Enclosure 2
Westinghouse APP-GW-GLR-607 Revision 3
(NON-PROPRIETARY VERSION)
(94 pages including cover page)

TITLE: Changes to Passive Core Cooling System Condensate Return

DCP/DCA/SUPPLEMENTS/EDCR # INCORPORATED IN THIS DOCUMENT REVISION:
APP-GW-GEE-5007

Figure 8: Personnel Airlock Gutter Modification Schematic

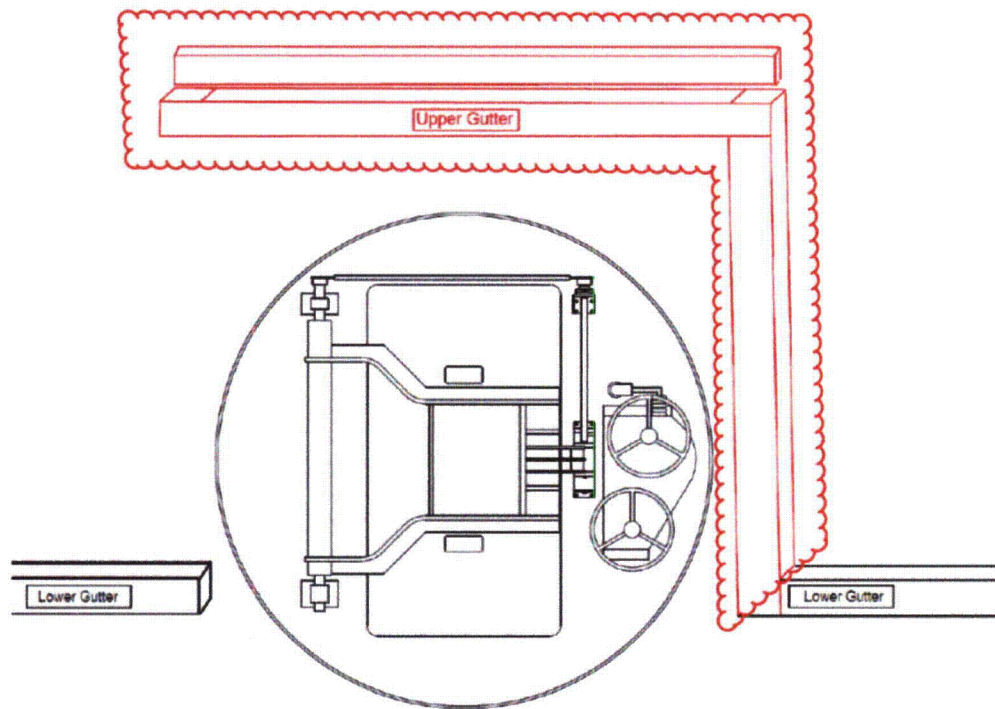
The original IRWST gutter was routed to the edges of the Upper Personnel Airlock and Upper Equipment hatch. [

] The IRWST gutter will be modified to have an upper gutter above each of the hatches that connects with the existing gutter. The extended gutter is of the same size as the sections which currently interface with the sides of the hatches. The gutter is sloped the same as the existing portions of the gutter. The extended portion of the gutter above the Upper Personnel Airlock is routed to interface with the lower portion of the gutter. Figure 8 shows a schematic of the proposed modification to the IRWST gutter to above the Upper Personnel Airlock. The Upper Equipment Hatch is similarly treated.

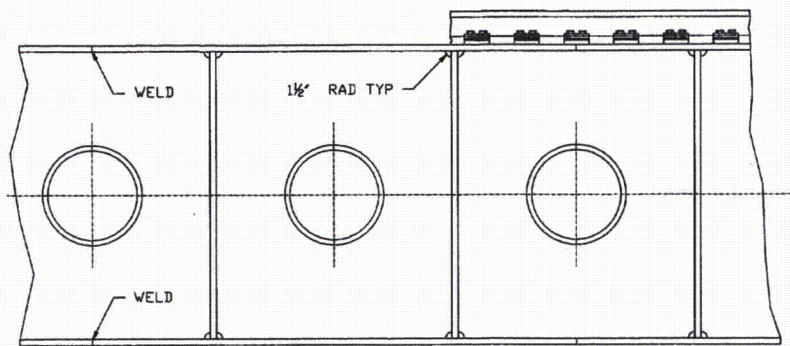
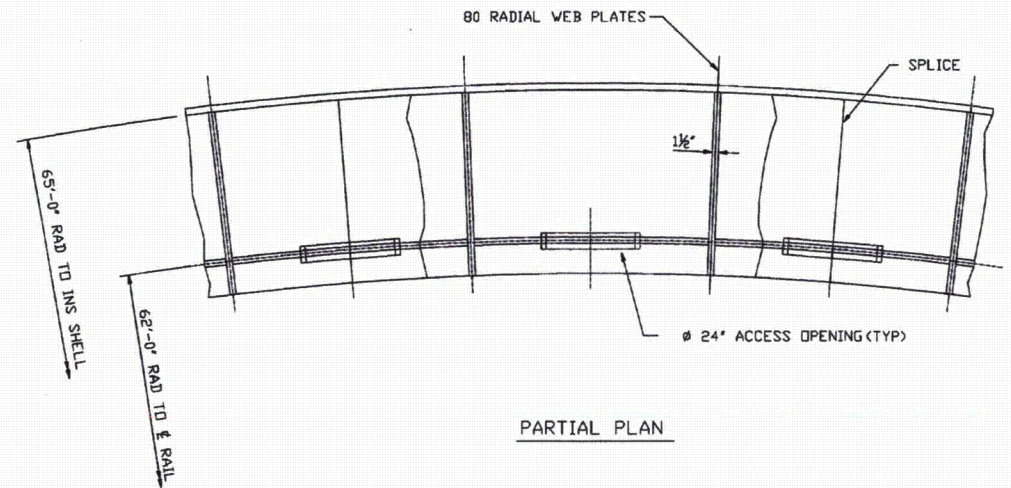
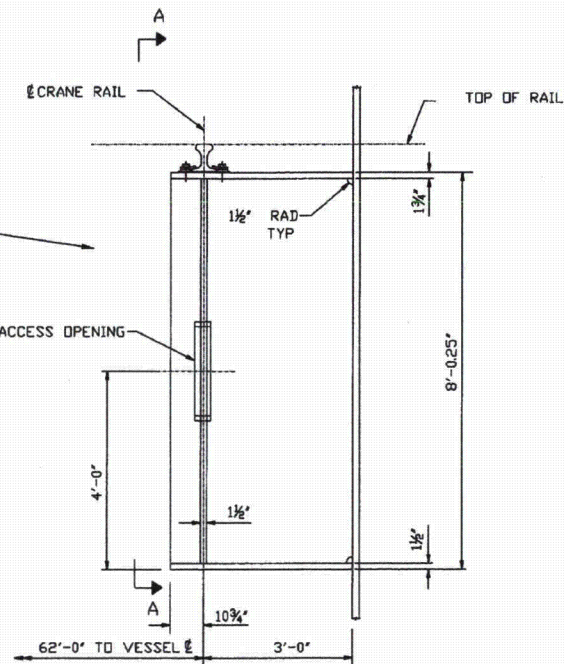
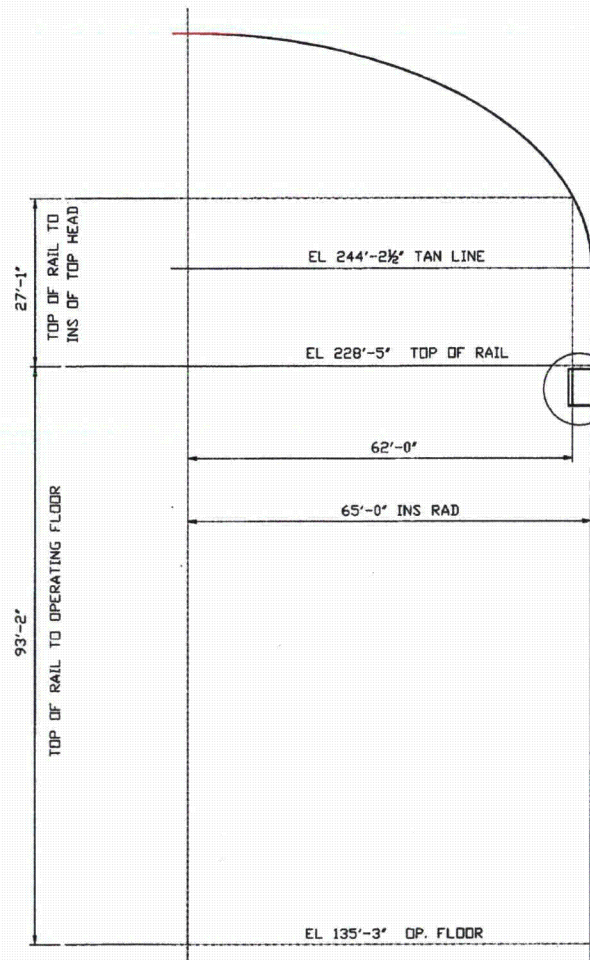
Pictorial detail of the PCG is shown in DCD Chapter 3. Figure 3.8.2-1 (Sheet 3 of 3) shows the fabrication holes in the top right figure. As the fabrication holes in the PCG would be blocked in the modified configuration, this detail ~~would~~ will be removed from this figure. The changes are shown in Appendix B.

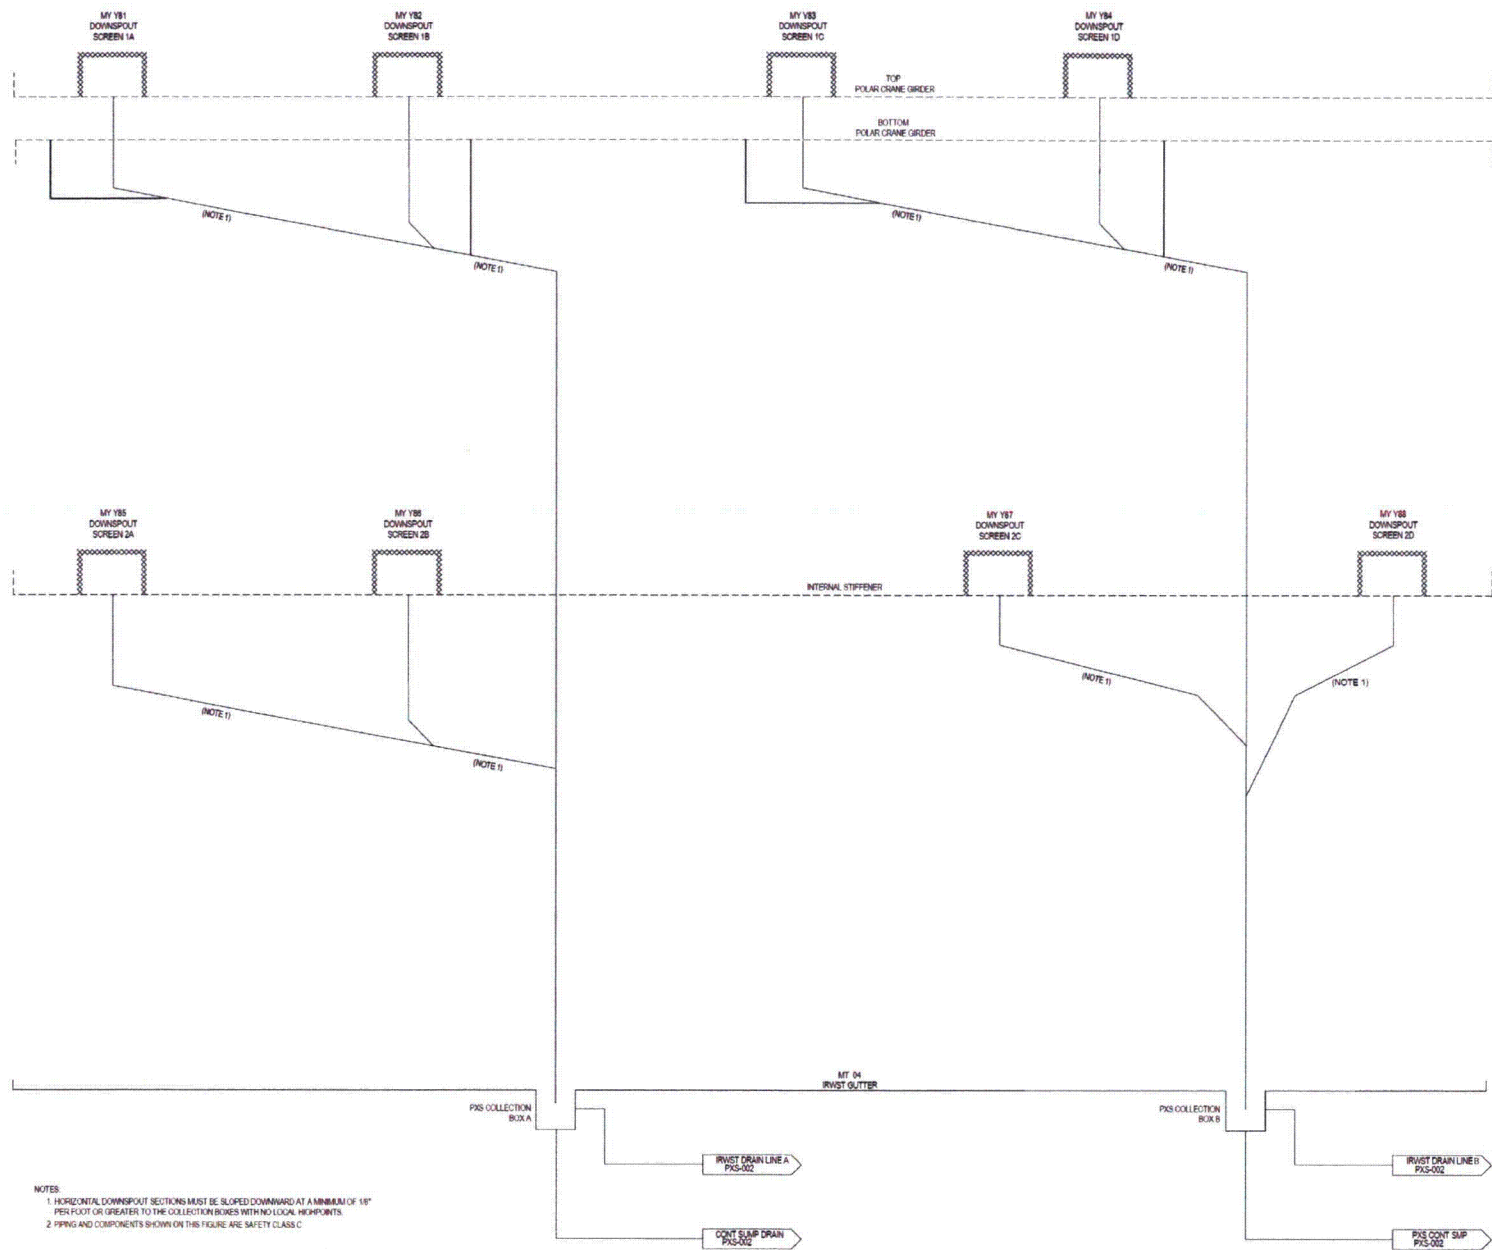
- Figure 6.3-2 will be relabeled Figure 6.3-1 (Sheet 2 of 3). On relabeled Sheet 2, the IRWST gutter has been relocated to a new sheet 3 of the PXS P&IDs. Sheet 2 has been modified to include continuation flags for condensate returning to the IRWST originating from PXS Collection Boxes A and B in the IRWST gutter.

- Figure 6.3-1 (Sheet 3 of 3) is a new P&ID sheet and will be added to the licensing basis. This new figure shows the relocated IRWST gutter and the screens and piping comprising the PXS downspouts originating from the Polar Crane Girder and internal stiffener.

Figure 6.3-2 not used.

(Renumbered as Figure 6.3-1, Sheet 2)

Figure 19E.4.10-1

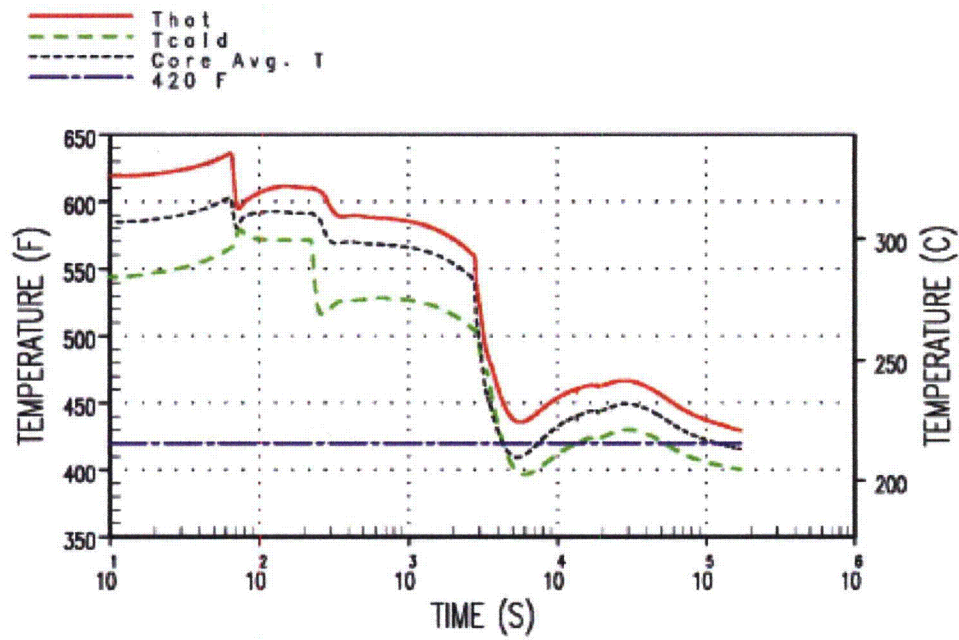
Based on the updates to the safe shutdown evaluation, the supporting licensing basis tables and figures need to be updated to reflect the current design. Section 19E.4.10.2, Table 19E.4.10-1, and the supporting figures, Figure 19E.4.10-1, -2, -3, and -4 will be updated by this change package.

Once actuated, at about ~~2,700~~4600 seconds, the CMTs operate in recirculation mode, injecting cold borated water into the RCS. In the first part of their operation, due to the ~~injection of cold water flow rate~~, the CMTs operate in conjunction with the PRHR ~~HX~~ to reduce RCS temperature. Due to the primary system cooldown, the PRHR heat transfer capability drops below the decay heat and the RCS cooldown is essentially driven by the CMT cold injection flow. However, at about ~~3,565~~6,000 seconds, the CMT cooling effect decreases and the RCS starts heating up again (Figure 19.E.4.10-1). The RCS temperature increases until the PRHR HX can match decay heat. At about ~~31,000~~ 46,700 seconds, the PRHR heat transfer matches decay heat and it continues to operate to reduce the RCS temperature to below 420°F within 36 hours. As seen from Figure 19E.4.10-1, the cold leg temperature in the loop with the PRHR is reduced to 420°F ~~at 82,600~~ 52,900 seconds, while the core average temperature reaches 420°F ~~within 123,600~~ 120,900 seconds (approximately 34 hours).
